Appendix C

Tribal Agency Position Supporting Materials

C1 INTRODUCTION

Figure I-05-02.2

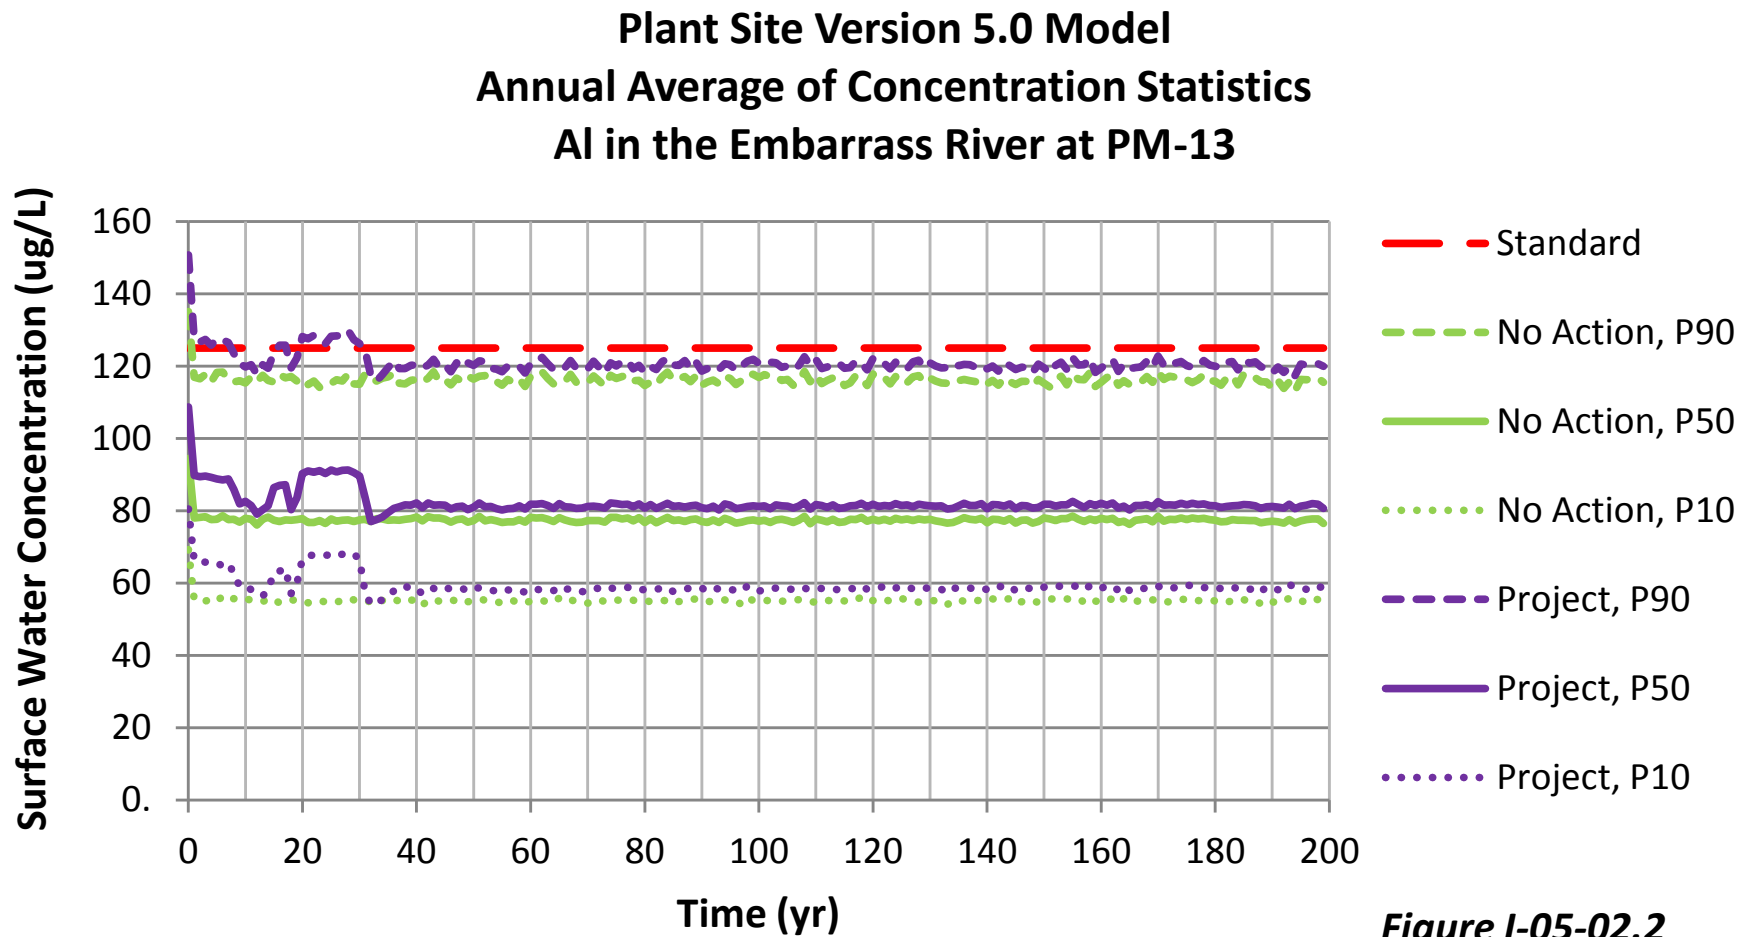
- - PSDEIS Table 4.2.2-29 shows that observed average Al at PM-13 is 221 ug/L. This observed average is much higher than the modeled No-Action (continuation of existing conditions) P50 annual maximum (PSDEIS Table 5.2.2-47, 159-166 ug/L). The modeled No-Action P50 annual average for Al at PM-13 of 75 ug/L (attached Fig.I-05-02.2, Water Modeling Data Package Vol 2-Plant Site v9 MAR2013) is only 1/3 of the observed average.

221 ug/L

average existing AI at PM-13 (PSDEIS Table 4.2.2-29)

Figure F-01-10.1

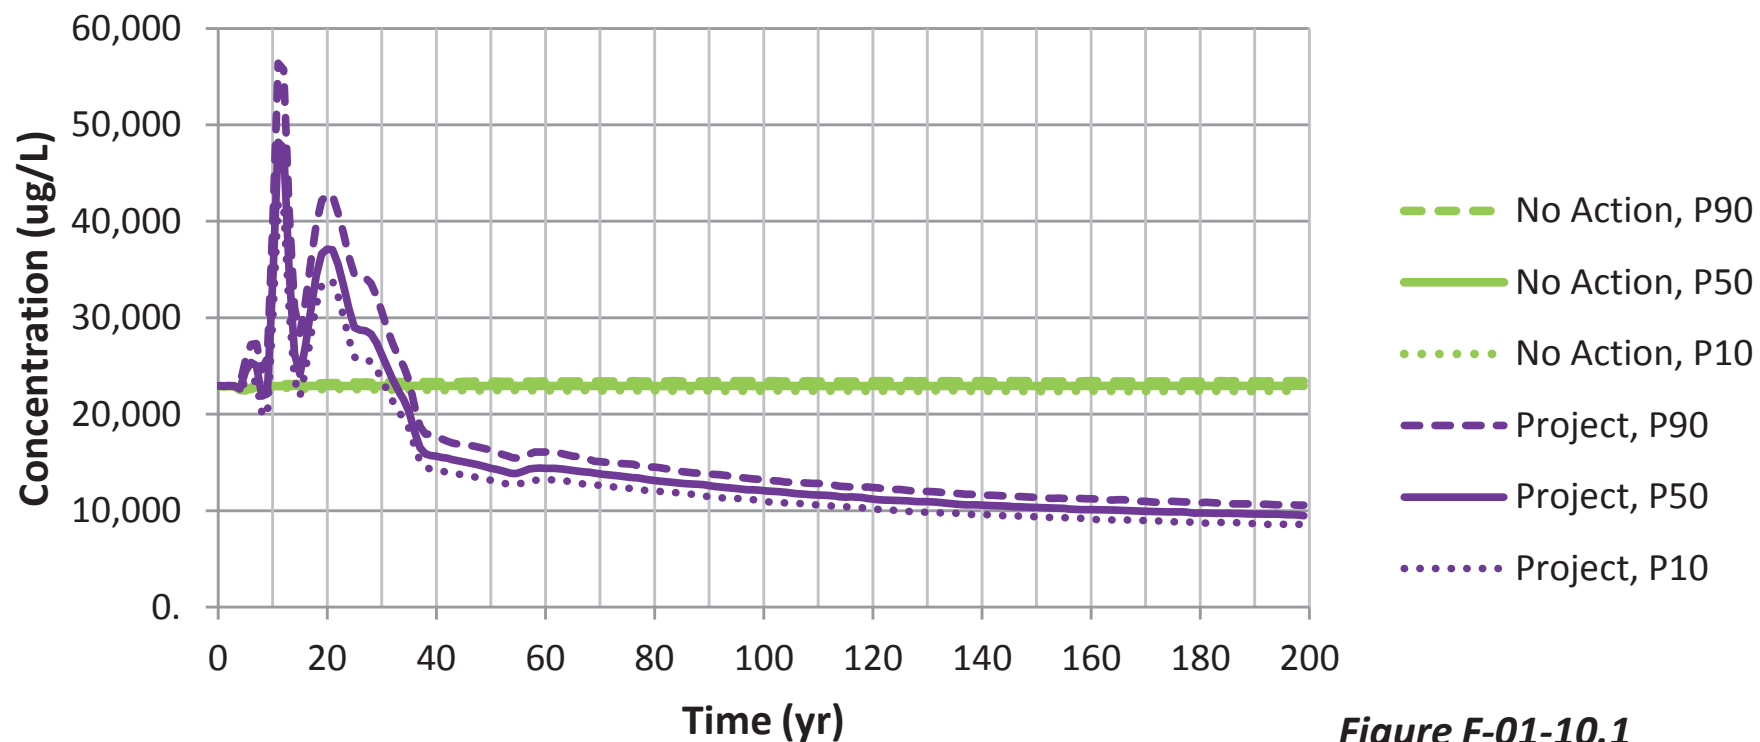
Based on the above CEQ guidelines, it is clear that activities that will occur under the Cliffs Consent Decree should be included in modeling of a No Action alternative. Unfortunately not only are the consent decree activities not included, but the fact that it will be precipitating on the tailings basins for the foreseeable future has not been included in the No Action modeling. This is evident by the model results that show stable levels of Chloride coming from the basins for the next 200 years (Figure attached) when there is no ongoing source for Chloride. With no source for new Chloride, rainwater will gradually dilute the residual Chloride in the basin and levels will drop. The PSDEIS claims that the basins water quality has stabilized and that the current conditions will not change over time. The claim of chemical stability is based on basin pond water sampling for only 4 years (2001 - 2004, PSDEIS Table 4.2.2-23).

Fig 4. 303d Impaired Waters Surrounding the Proposed Polymet Mine

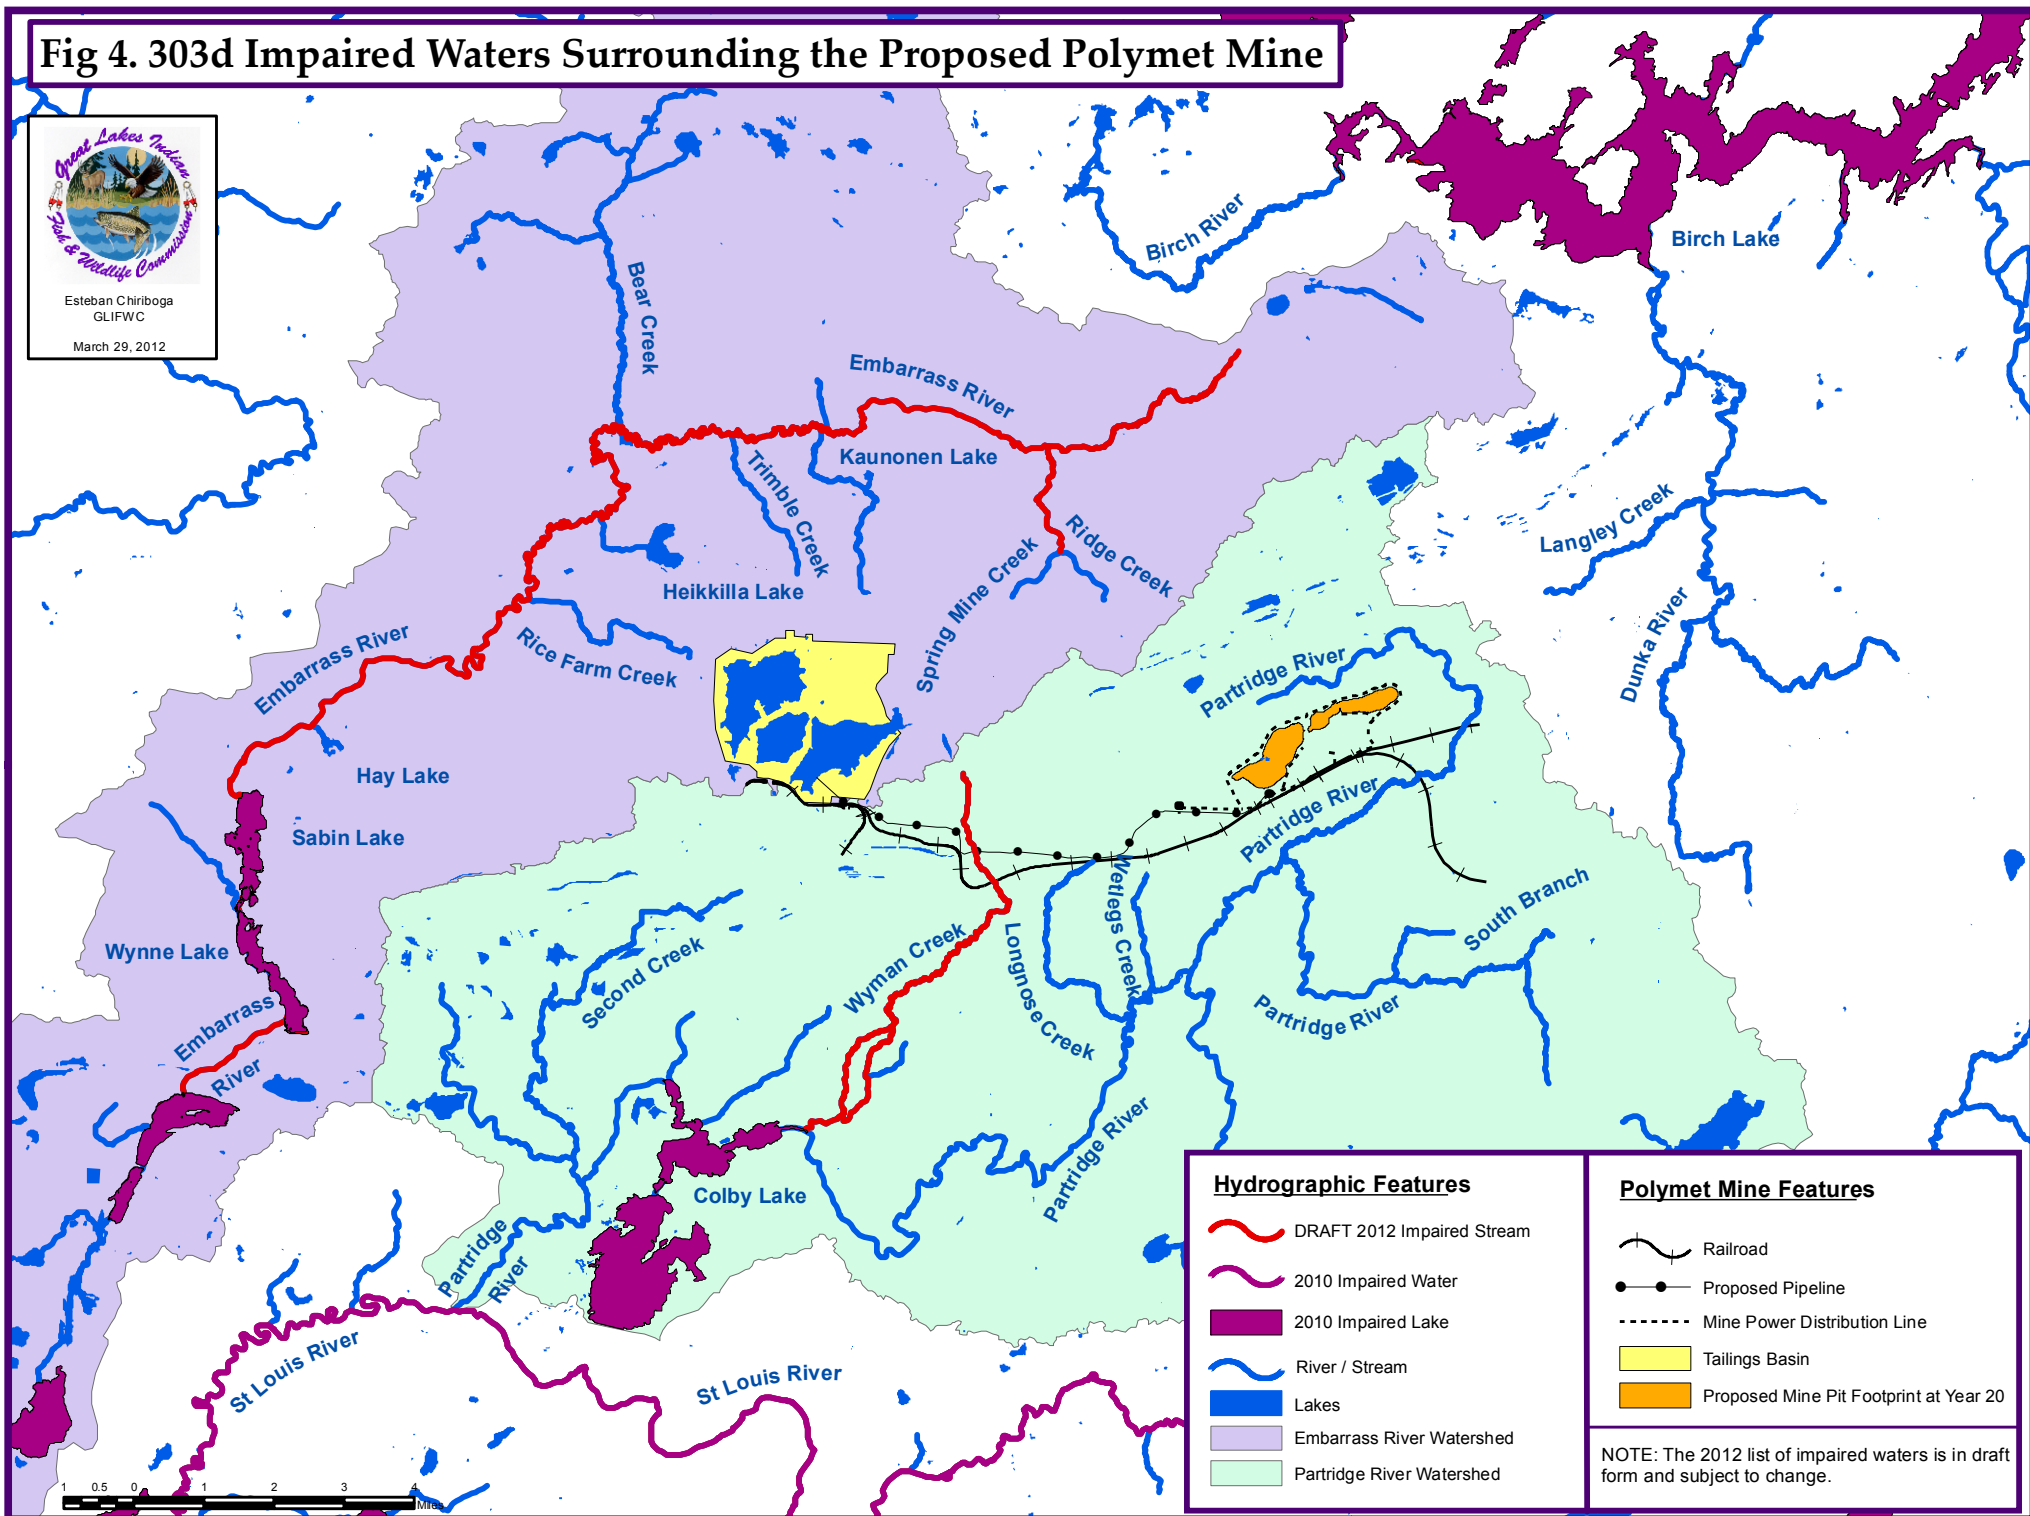
4.2.6 Aquatic Species					
GLIFWC 84	GLIFWC	4.2.6.4 Mercury Concentrations In Fish	The discussion of 303d listing is not correct because the Embarrass River is on the 2012 303d list. See GLIFWC map of 303d waters in the wild rice attachment (figure 3). Sulfate has a link to mercury methylation which is directly related to mercury contamination in fish. This should be noted here.	Text revised to clarify the current status of 303(d) listings. The Embarrass River is on the 303d list as impaired for Fishes Bioassessment, a category not related to mercury.	ok. However it should be noted that the Embarrass river is expected to be impaired for sulfate in the next draft list. Language regarding changes to 303d lists should be added.

Figure 23. Annual Maximum of Concentration Statistics: Chloride at the North Toe.

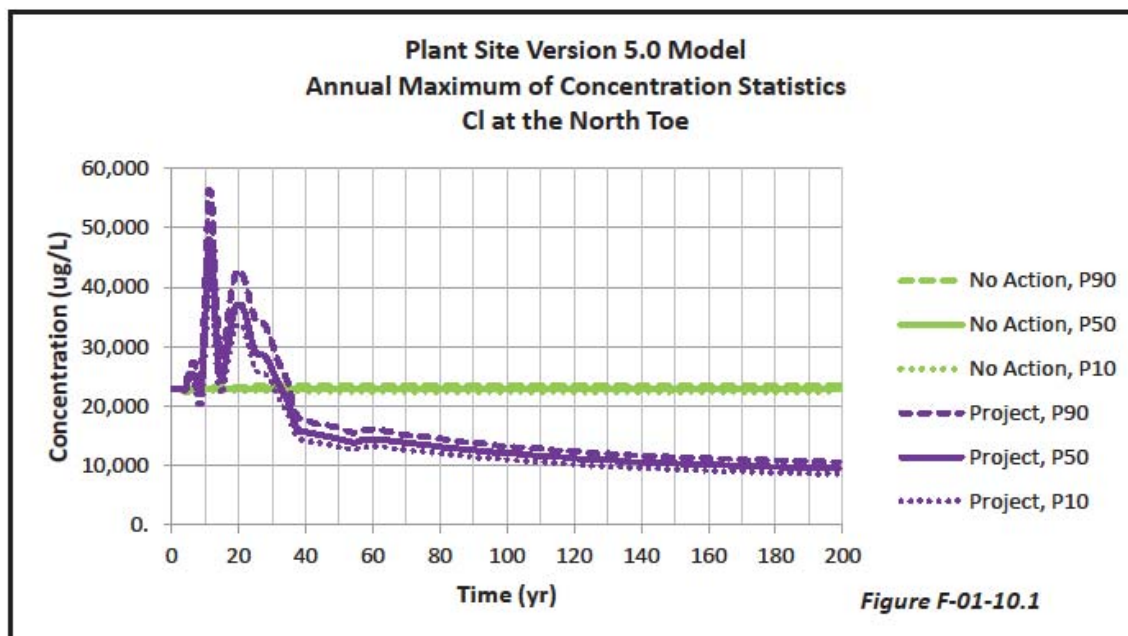
Based on the above CEQ guidelines, it is clear that activities that will occur under the Cliffs Consent Decree should be included in modeling of a No Action alternative. Unfortunately not only are the consent decree activities not included, but the fact that it will be precipitating on the tailings basin for the foreseeable future has not been included in the No Action modeling. This is evident by the model results that show stable levels of chloride coming from the basin for the next 200 years (Figure 23) when there is no ongoing source for chloride. With no source for new chloride, rainwater will gradually dilute the residual chloride in the basin and levels will drop. The PSDEIS claims that the basin's water quality has stabilized and that the current conditions will not change over time. The claim of chemical stability is based on basin pond water sampling for only 4 years (2001 – 2004, PSDEIS Table 4.2.2-23).

Since there has been no water quality data collected in the basin pond for 9 years it is reasonable to assume that the past 9 years of precipitation has diluted the water chemistry in the basin pond, and that eventually the more dilute water will percolate through the basins and be discharged at the toe. If chemical stability is to be assumed, more recent data on basin pool water chemistry is needed. While the CEQ makes it clear that a blind "continuation of existing conditions" model is inappropriate as a No Action alternative, a "continuation of existing conditions" model that ignores simple environmental processes such as precipitation is even less appropriate.
